CHATSWOOD TO SYDENHAM  
**VICTORIA CROSS STATION  
AND ARTARMON SUBSTATION  
MODIFICATION  
SUBMISSION REPORT**

# Executive summary

## Purpose of this report

Figure 2-2 Revised setbacks – Victoria Cross Station

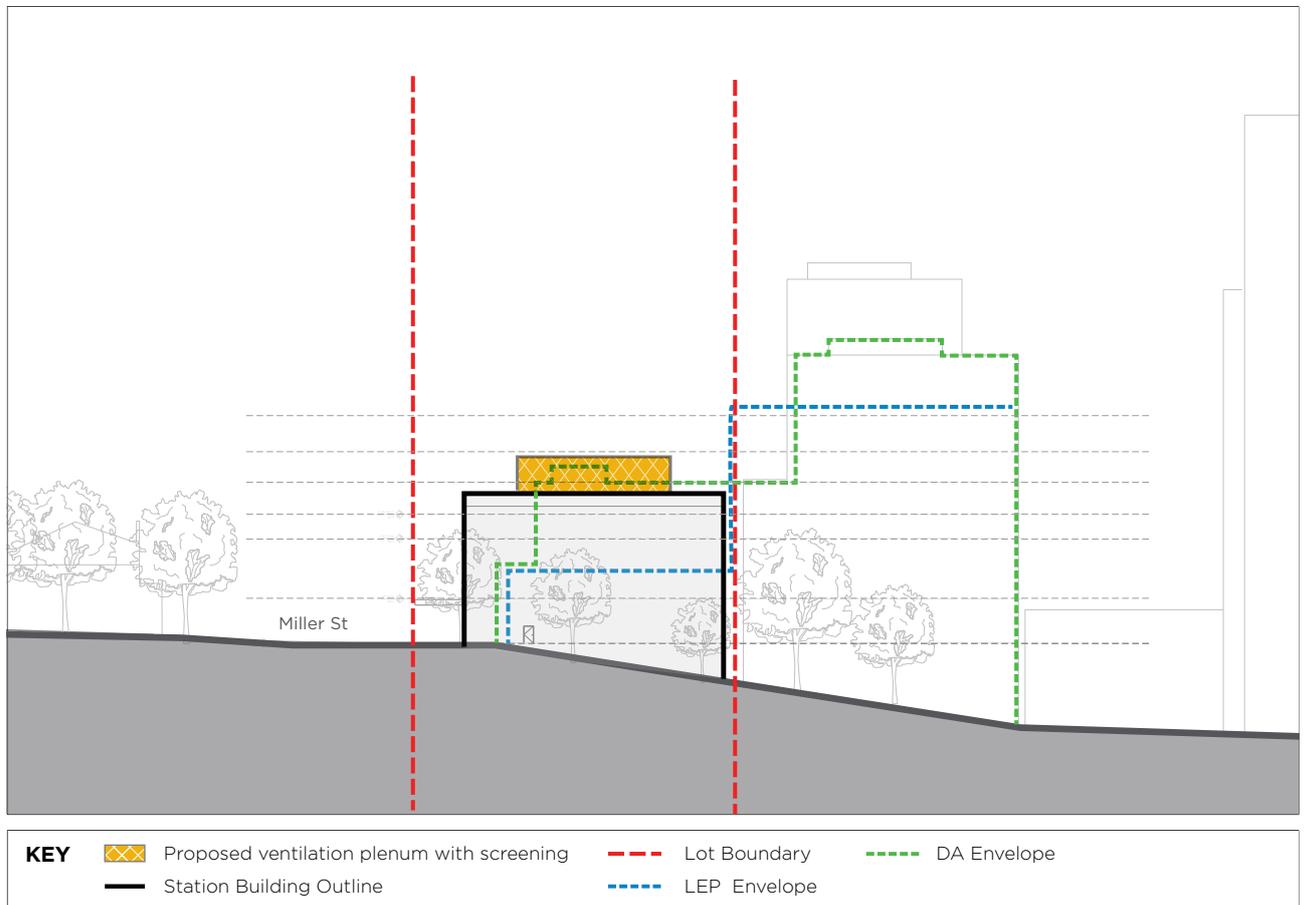
The setback to McLaren Street has been reduced from 4.5 metres to 1.2 metres. This was required to allow an increase in the setback to the boundary with 243 Miller Street (to around 3.3 metres) and reduce potential impacts on several trees at that location. The revised setbacks are shown in plan view on Figure 2-2 and as a cross section (for the Miller Street setback) on Figure 2-3.
